# Architectural Review Board

## Staff Report (ID # 10068)

<b>Report Type:</b>	Subcommittee Items	<b>Meeting Date:</b> 3/21/2019
<b>Summary Title:</b>	3200 El Camino Real: Subcommittee Review of Architectural Details	
<b>Title:</b>	3200 El Camino Real [17PLN-00156]: Subcommittee Review of a Previously Approved Project That was Conditioned to Return With Project Changes to Address Architectural Details. Environmental Assessment: An Initial Study Prepared in Accordance With the California Environmental Quality Act (CEQA) was Circulated Between December 5, 2018 and January 4, 2019. Zoning District: Service Commercial (CS). For More Information Contact the Project Planner Sheldon S. Ah Sing at sahsing@m-group.us.	
<b>From:</b>	Jonathan Lait

**RN SERIES**  
**C - CABINET KNOCKDOWN CURB HORIZONTAL**  
**AIR COOLED**  
**~ 16 - 30 TON**

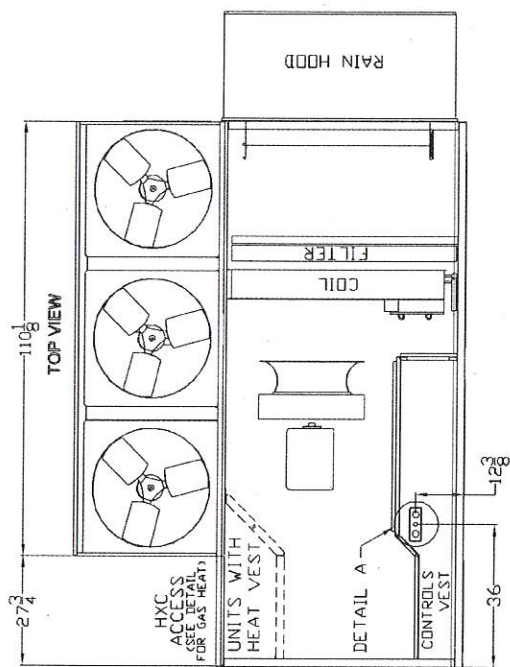
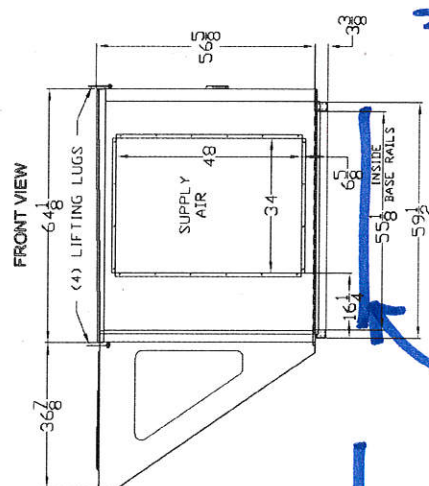
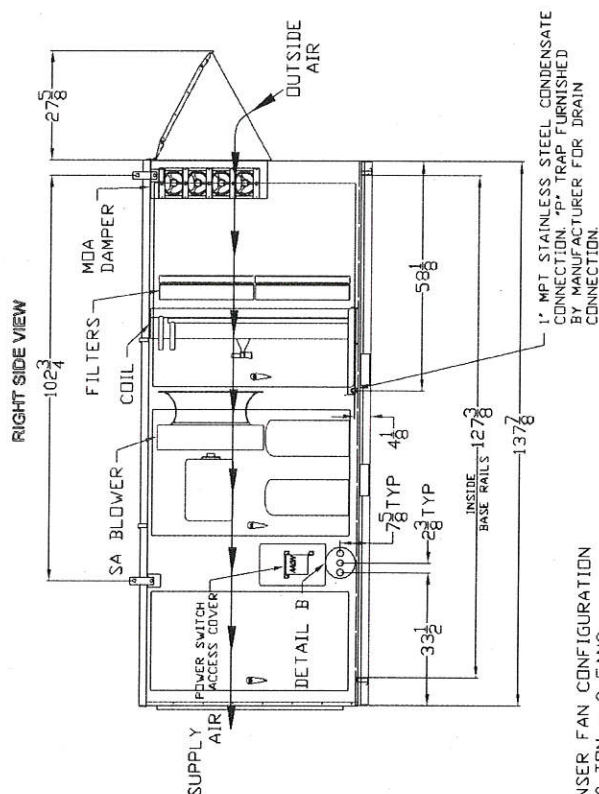
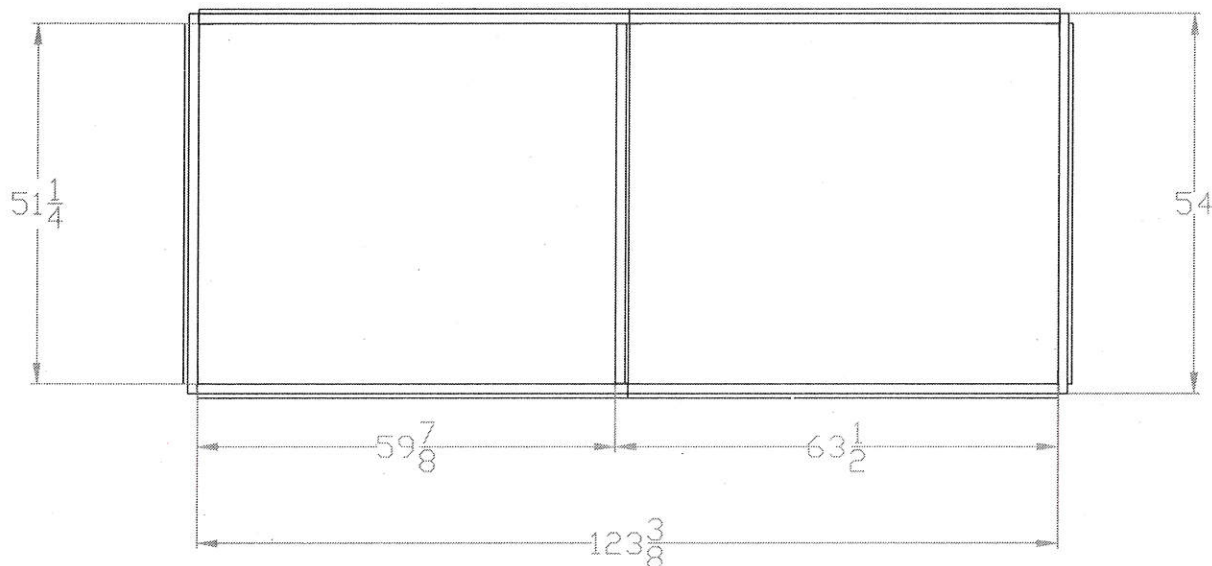
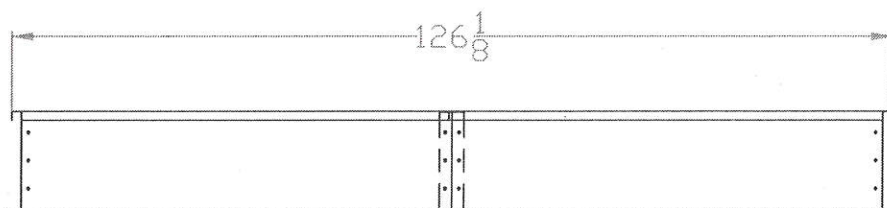
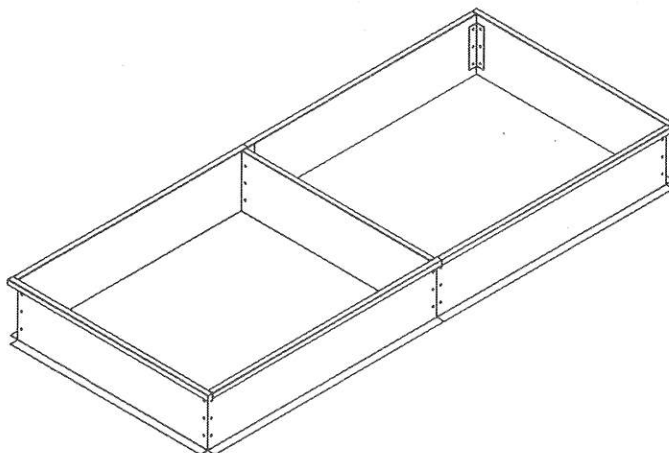
- Provide clarification of mechanical roof screening.

5. Vertical height of screen wall on roof. It is our understanding that subcommittee would like to take a review the height of the mechanical screen at the roof. Our most current drawings show a 10' tall screen element (15' is allowed) to screen view to mechanical equipment that is no taller than 8' off the roof elevation. Attached is a cut sheet on the tallest piece of equipment we will use.

The most current plans show a 10-foot tall screen to screen equipment that is 8-feet tall from the roof. The mechanical equipment is located in the center of the roof and the screening is recessed approximately 10-feet from the roof edge.

The concern from the Board was that the screening may be too tall. The screening need only to obscure the rooftop equipment from public view and that the screening is recessed where feasible. The screen wall height should not exceed the height of the equipment. It is possible that based on the line-of-sight a shorter wall would screen the equipment. Staff has asked the applicant to bring line-of-sight diagrams to the subcommittee hearing for review.

FIXTURE SPECIFICATIONS

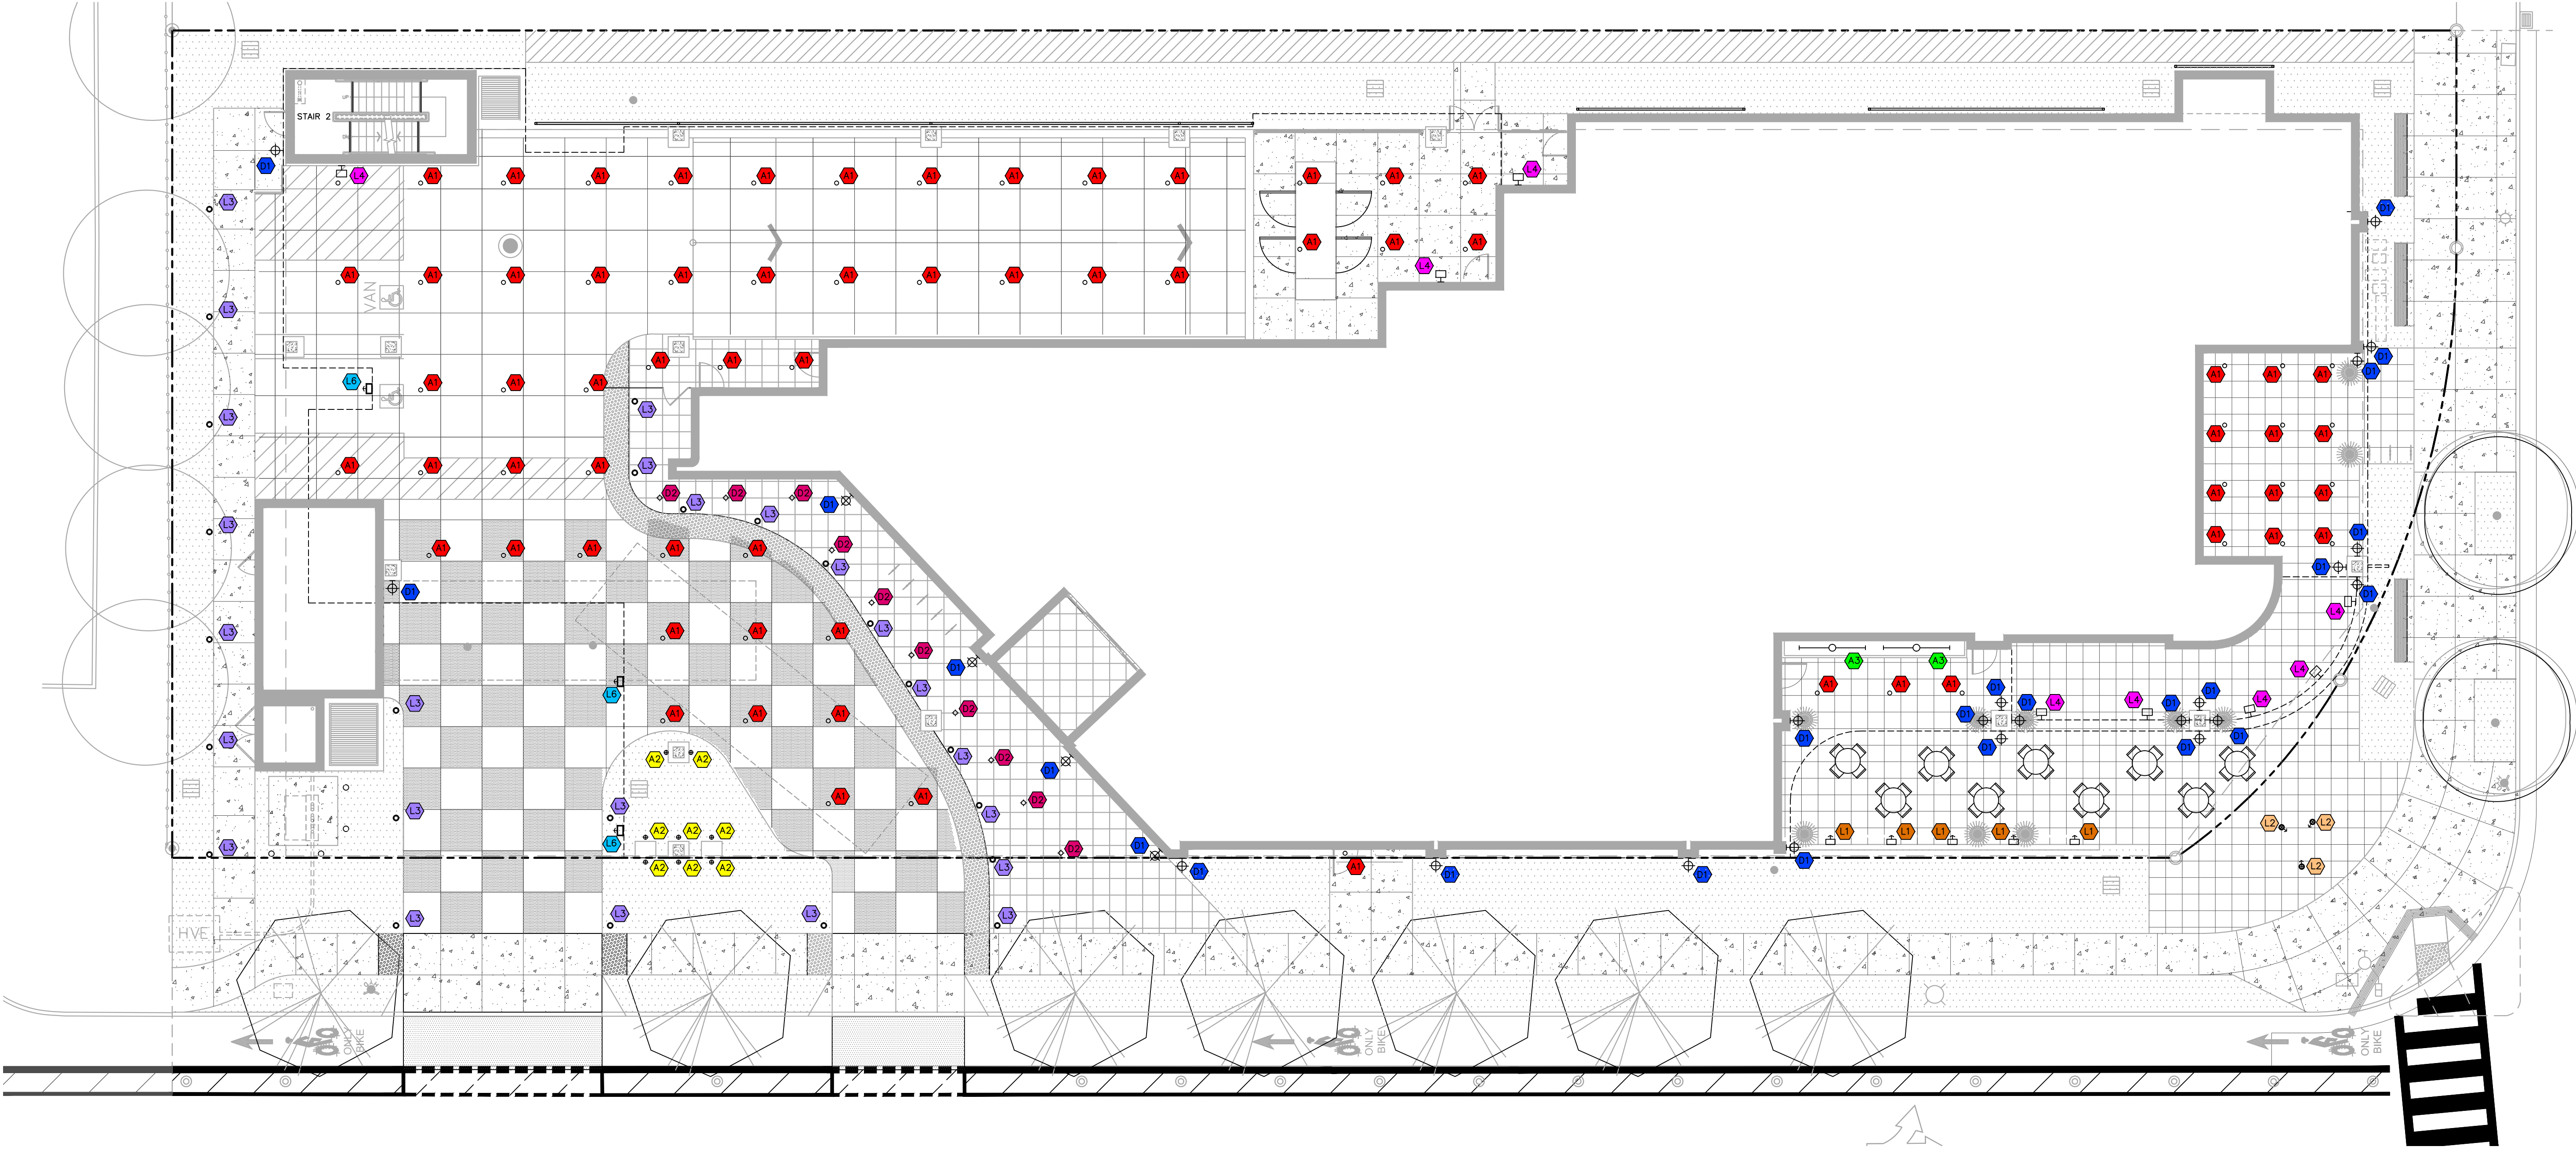
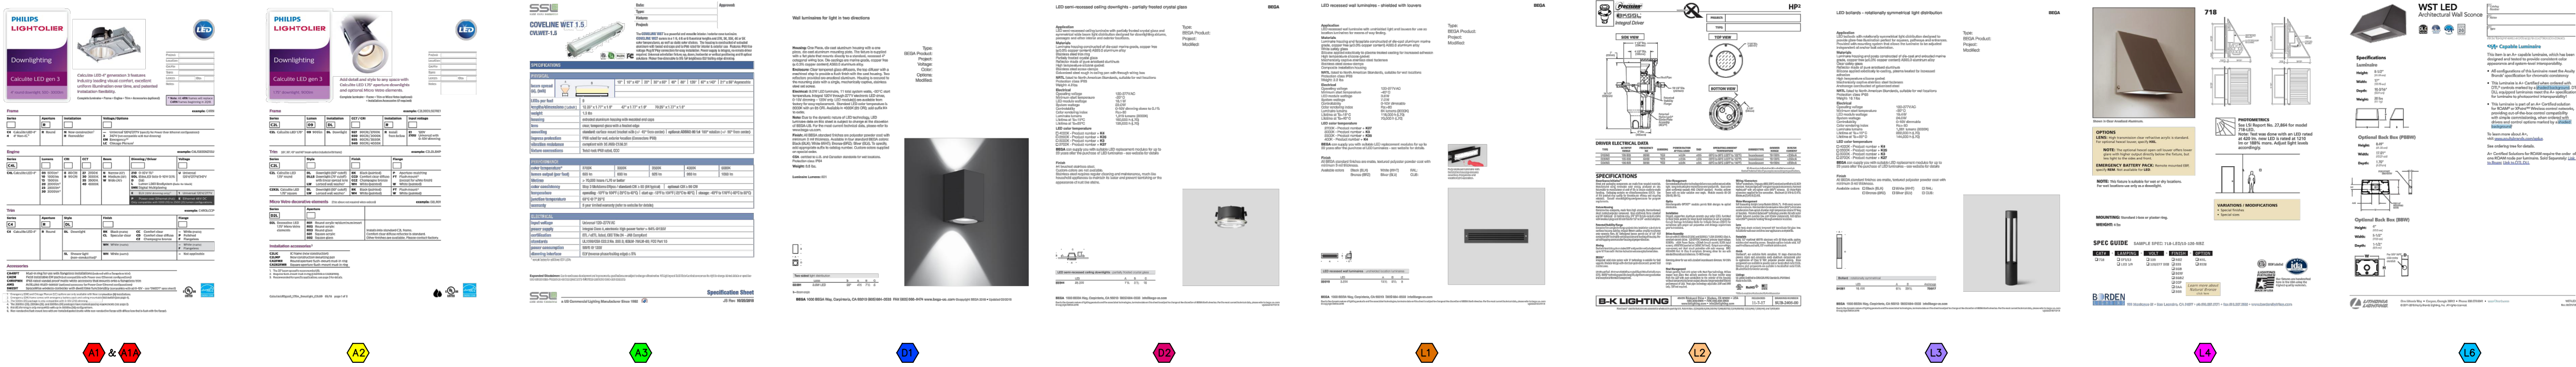
- Provide replacements and details of exterior light fixtures

The Board had concerns regarding the type of light fixtures used on the northwest elevation. The downlighting was good, but a higher-quality fixture was desired. New fixtures details have been provided.

Plans show updated fixtures and the locations of those fixtures.

6. Light fixtures. The Board requested that we take a look at exterior light fixtures. We have updated the fixtures and attached herewith the cut sheets. I will send you a pdf site plan on Monday that shows where all the lights go.
